ANSI SAFETY Aviation
 HOOK ASSY
 DWG NO. 442868
 CAGE CODE 35FB9
 REVISION J
 SHEET 1 OF 1

Engineering Change Order

ECO# 650	Priority# 2	Date: 9/6/2012
Submitter: BRIAN BURNS	Department: ENGINEERING	Extension:
Drawing No.: 442868	Product Line: Seatbelts	Change Level: <input checked="" type="radio"/> Class I <input type="radio"/> Class II
Rev J	Product Used On:	
Drawing Title: HOOK ASSEMBLY		Desired Release Date: 9/20/2012

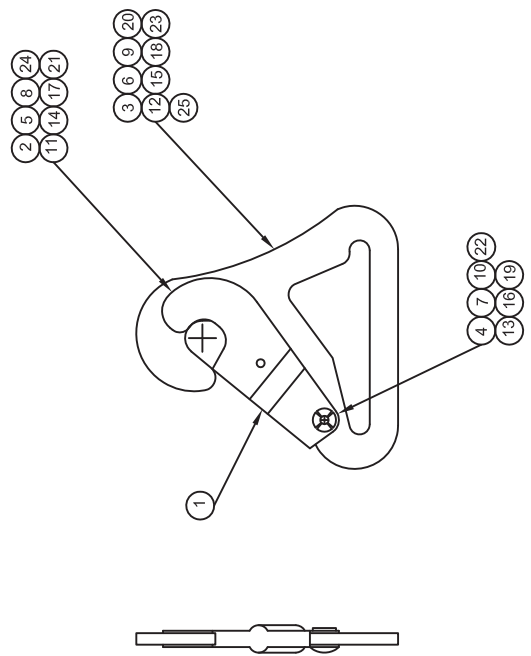
Reason for Change:
 CAR 2012-91 DESCRIBES DISCOLORATION OF THE PLATING ON THE 442868-405-150. THIS ECR CHANGES TO AN EQUIVALENT PLATING THAT IS MORE CONSISTENT.

Description of Change: (If Multiple DWGs, List PN/Rev/Description)
 ADDED "USE HOOK 442904-3-452" TO NOTE 5; ADDED NOTE 5 TO ITEM 23.

- AFTER SWAGING RIVET, CLIP MUST MOVE FREELY.
- HOOK ASSY MUST ACCEPT AND CAPTURE Ø.375 ROD.
- MIN RATED STRENGTH; MUST MAINTAIN 3000LB. STATIC TENSILE.
 SECOND DASH NO. AND FINISH CORRESPONDS TO DASH NO. AND FINISH OF E503541. I.E. P/N 442868-405-1 FINISH= NICKEL BLACK PER E503541.
 FOR P/N 442868-405-150 USE RIVET P/N 442689-67-393, USE CLIP P/N 442908-3-481 AND USE HOOK 442904-3-452
